Response to NRC's ltr dtd 02/07/78  
...Furnishing addl info on the analysis of the  
Steam Generator Subcompartment Pressure Response...  
Notorized 02/27/78...

Donald C. Cook Nuclear Plant Units 1 & 2  
Docket Nos. 50-315 and 50-316  
DPR Nos. 58 and 74  
Steam Generator Subcompartment Pressure Response Analysis

In his letter dated February 7, 1978, Mr. Kniel of the Division of Project Management requested additional information on the above cited analysis. An item by item response to Mr. Kniel's request is enclosed herein.

FIGURE 2.9

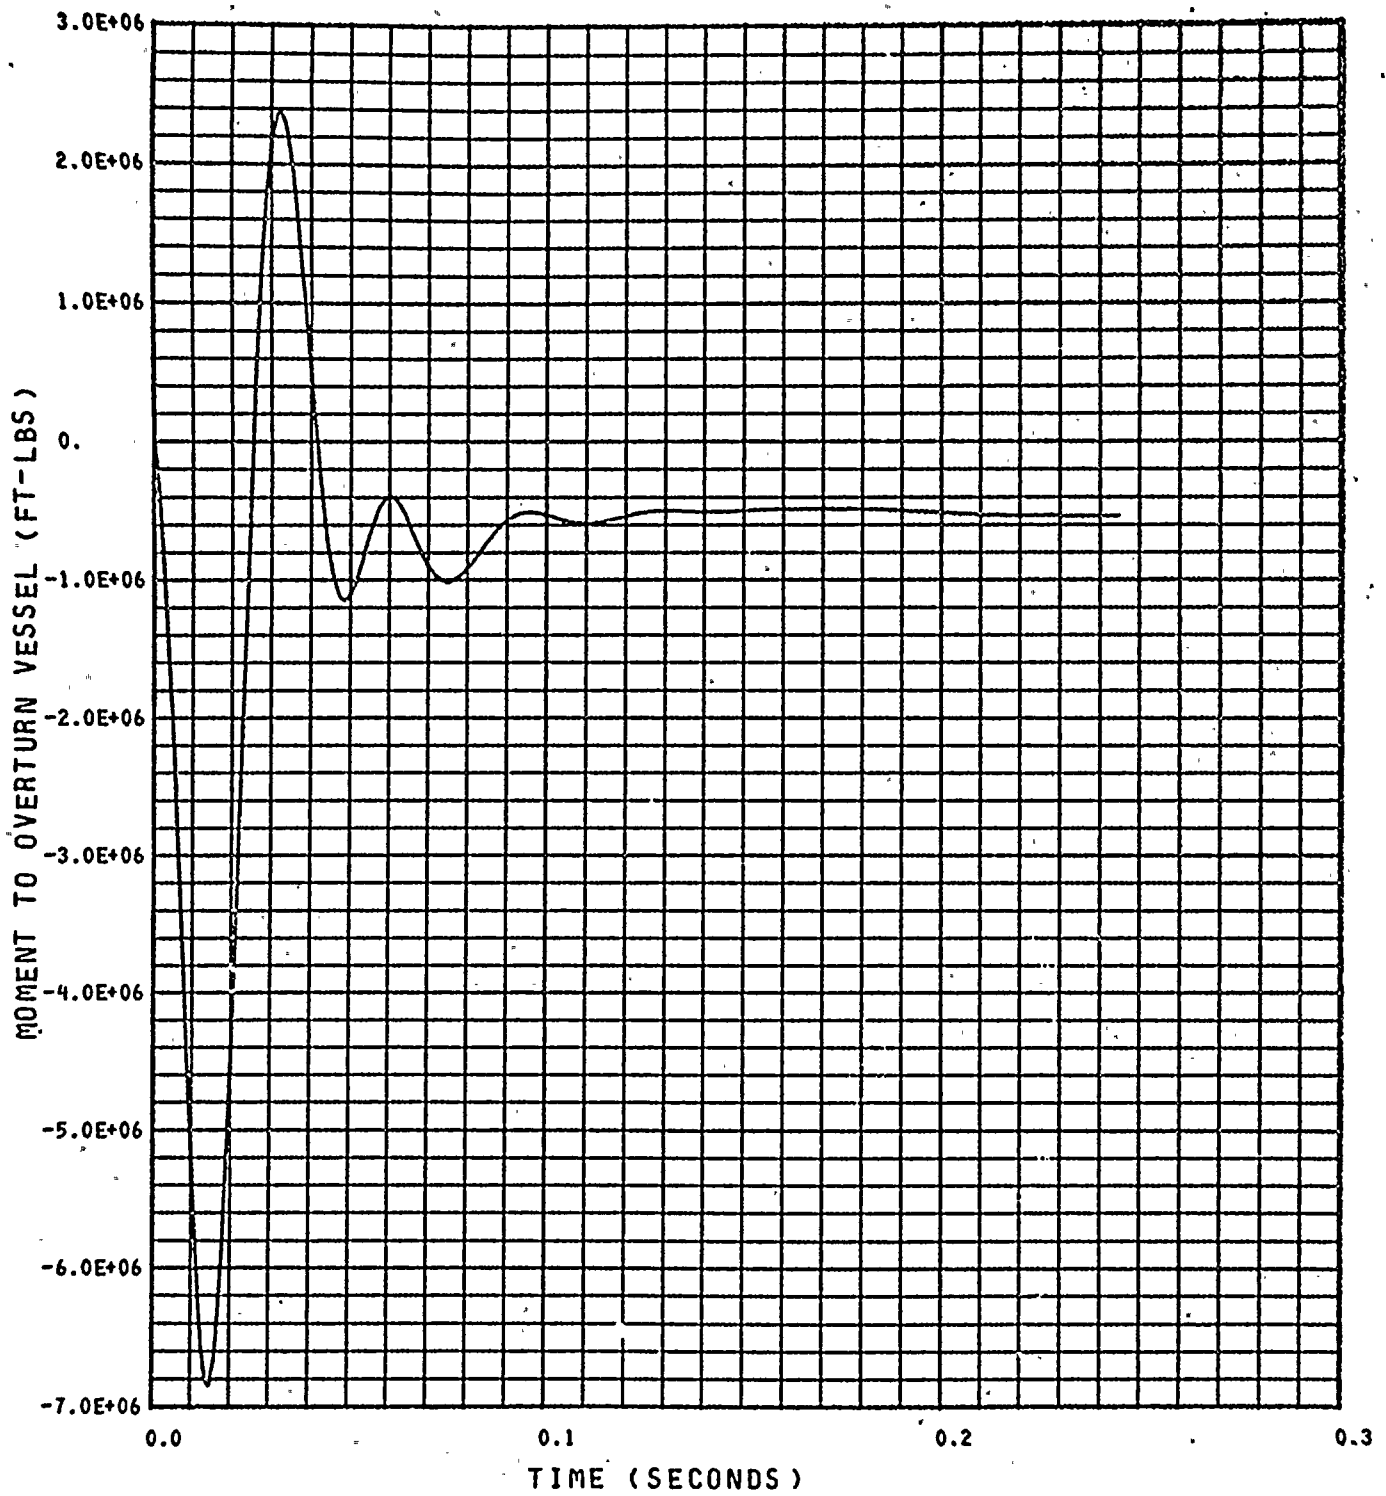
2. Provide figures which (a) identify the peak forces and moments acting upon the steam generator for each of the models used in the sensitivity studies (i.e., five, nine and seventeen node models) and (b) demonstrate that the loads transmitted to the steam generator supports are maximized by the nine node model.

- (a) Table A presents the peak steam generator loads and the time of occurrence for the five, nine and seventeen node models. Figures 2.1 through 2.9 present the horizontal (same as axial) force time history, the vertical force time history, and the moment time history for each of the three models evaluated in the nodal study.

- (b) Only the peak inertial negative moment for the five and seventeen node models were slightly higher than the peak inertial negative moment for the nine node model. The calculations of the steam generator support loads were made by combining the forces and moments without consideration of time phasing. This conservatism would result in the nine node model submitted encompassing the resultant support loads using a time phase analysis with the other 2 models. This can be seen by noting from the attached information that the peaks are quite narrow and do not occur at the same time.

TABLE 1

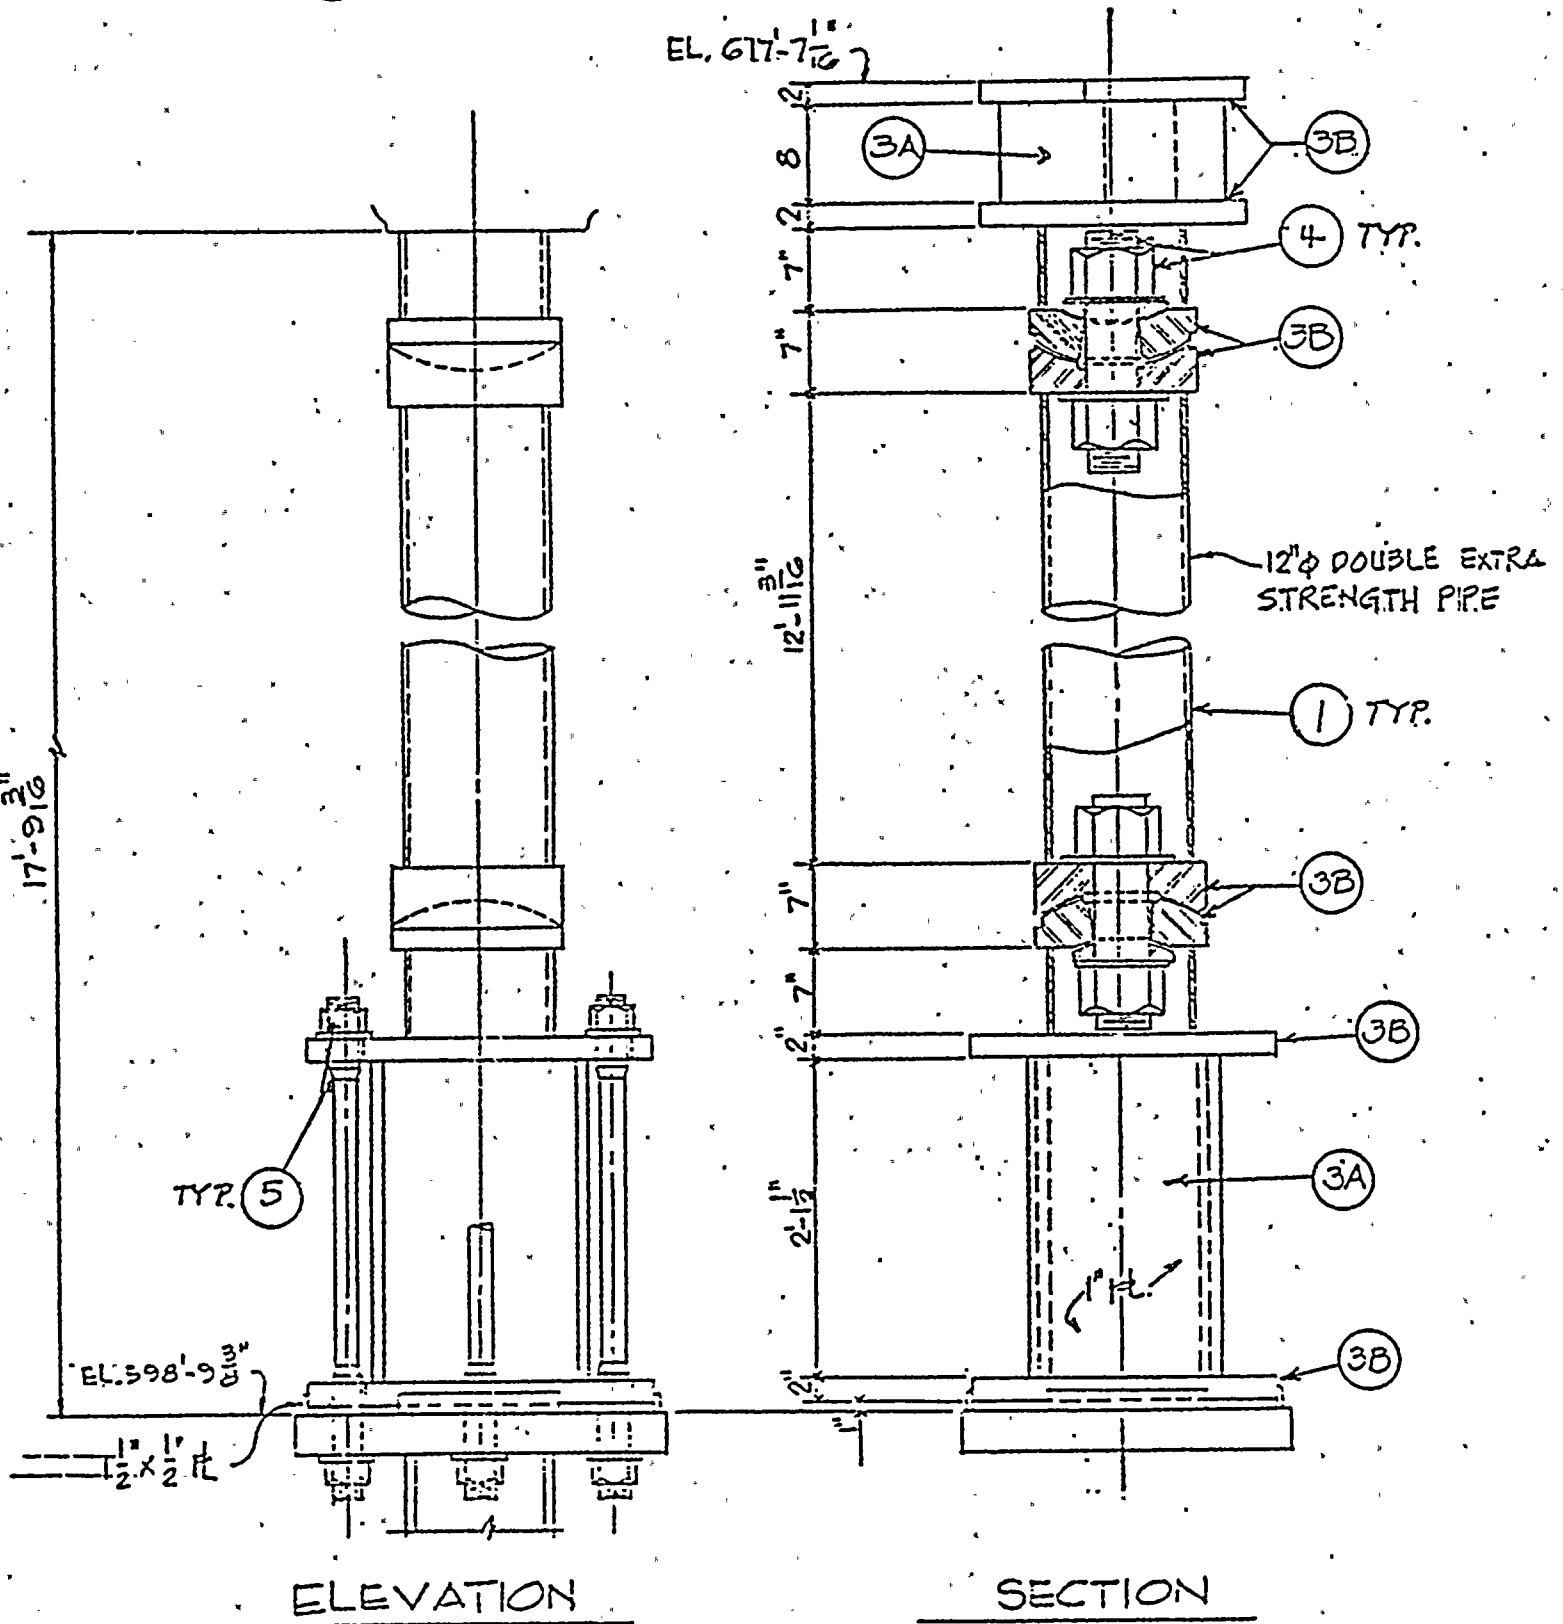
3. Provide the criteria including any limitations on component buckling used for determining the design load capacity of the critical elements in the vertical column support systems and the upper lateral support structure. In addition, identify the materials and the minimum specified properties for these support members.

The material used for the steam generator upper lateral support is designated 3A. Provided in Table 1 are the material type, minimum properties and testing required for this designation. The material designation for the vertical supports is given in Figure 1 and the material type, minimum properties, and testing required are given in Table 1.

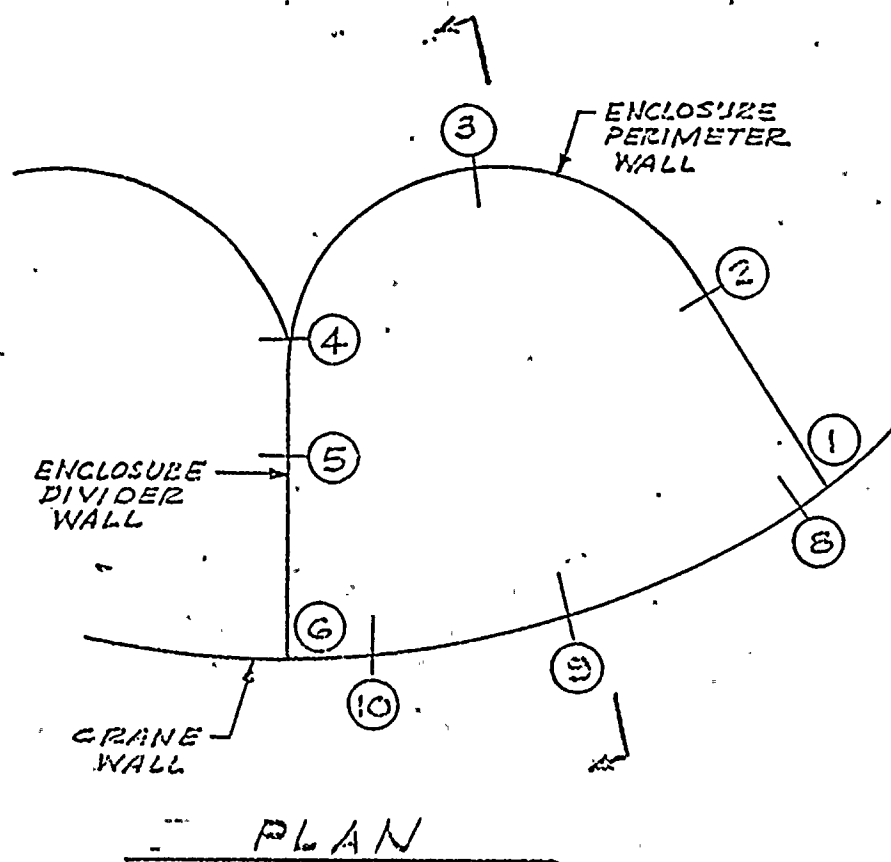
4. Describe briefly (a) the capability of the FELAP computer program; (b) how FELAP was utilized in the analysis; (c) the mathematical model and assumptions made; and (d) how the FELAP results were verified.

(c) The steam generator enclosure was modeled as a series of quadrilateral finite elements with constant Modulus of Elasticity (E) and constant Plate Moment of Inertia (D).

The stiffness and modal methods of analysis were employed coupled with the finite element method and the assumption of small deflection, linear-elastic structural theory.

The enclosure was considered to be laterally restrained at its base along the perimeter wall by the containment operating deck slab at El. 652' - 7 1/2" and supported along the crane wall segment by the lower inlet door piers. The crane wall segment of the model was carried beyond the limits of the perimeter wall and considered fixed by the balance of the crane wall.
